CONSTRUCTION CHANGE DIRECTIVE

PROJECT: Hidalgo County ADC & LEF Repairs and/or Replacement
701 El Cibolo Rd. Edinburg, TX 78542

DIRECTIVE NUMBER: 1
DATE: 5/29/2015
ENGINEER'S PROJECT NO.: 13159

April 23, 2015
Hidalgo County Adult Detention Center West Side Metal Roofs

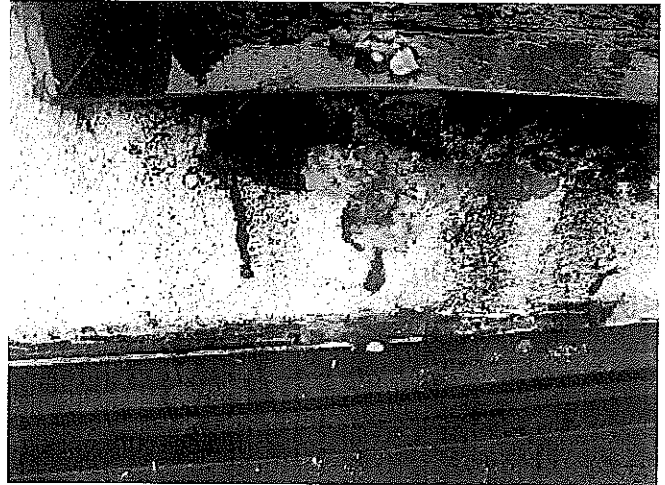
Sealant installed at entire perimeter of through wall scupper.

Sealant present at surface mounter counter flashing of metal roof.

Tremco would recommend a full replacement of the existing metal roof. A full replacement would ensure the roof would be insulated bring it up to current code and would ensure a complete underlayment would be installed to prevent leaks in any senerio.

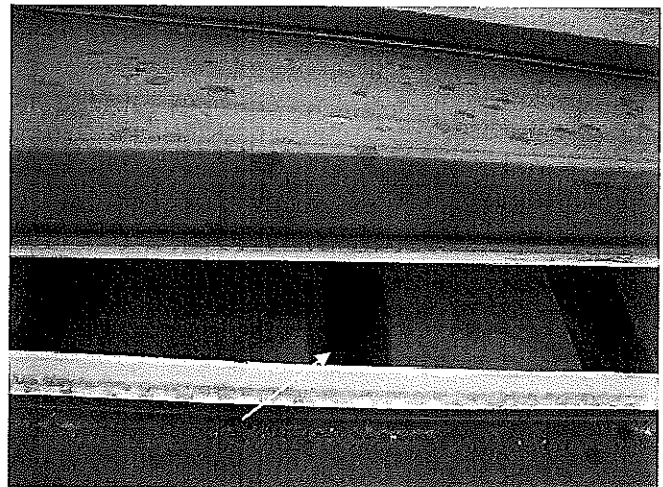
Snap lock panel is easily removed. No underlayment present. Metal panels are installed directly to the metal deck.

HIDALGO COUNTY ADULT DETENTION CENTER
 701 EL CIBOLO ROAD

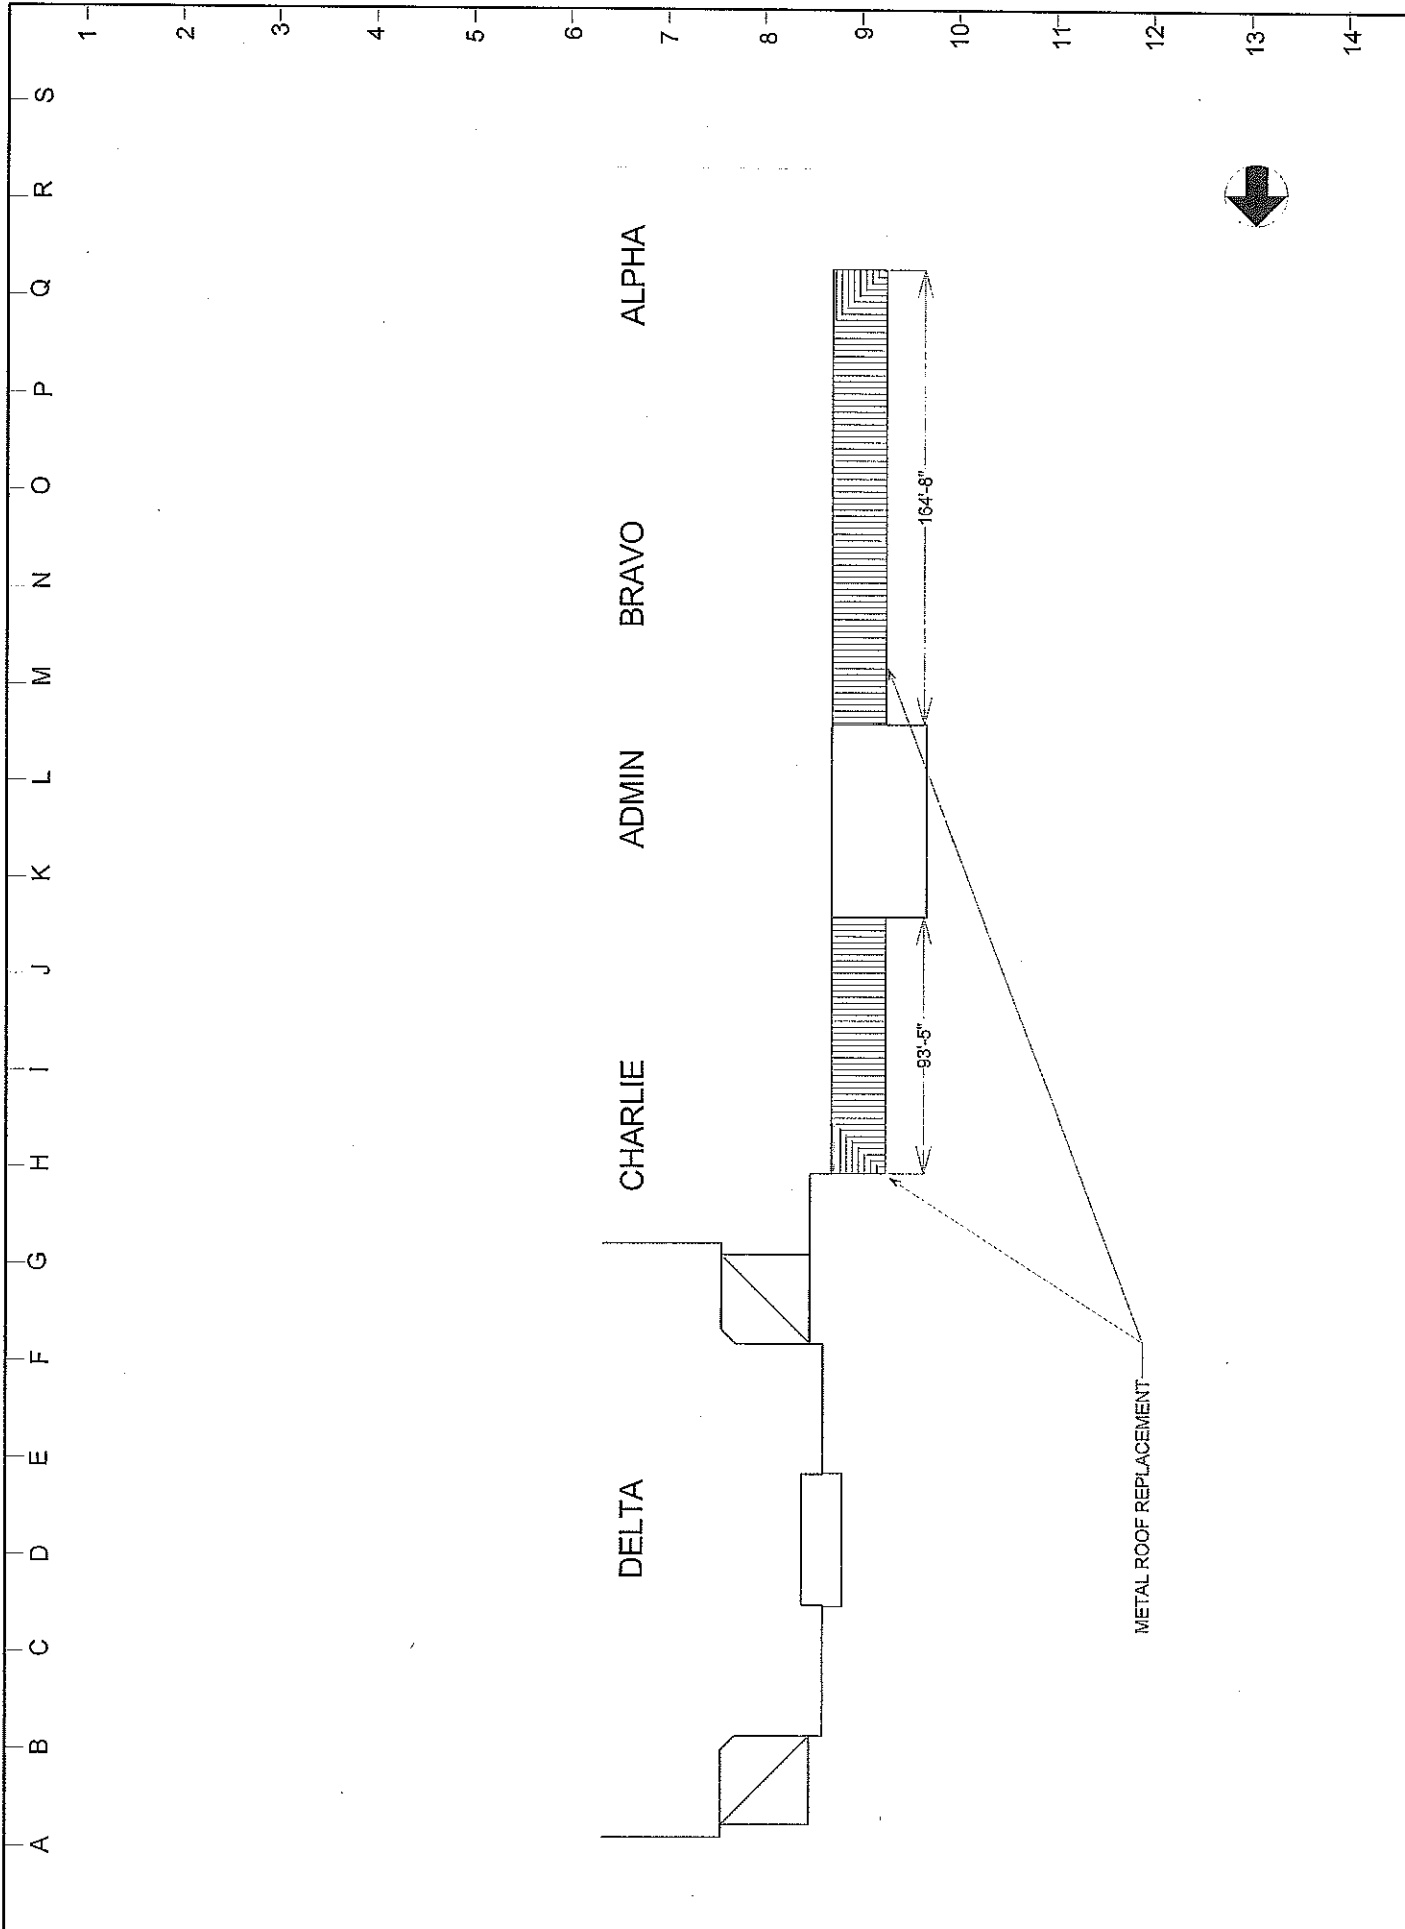
Water is present in metal deck corrugations.
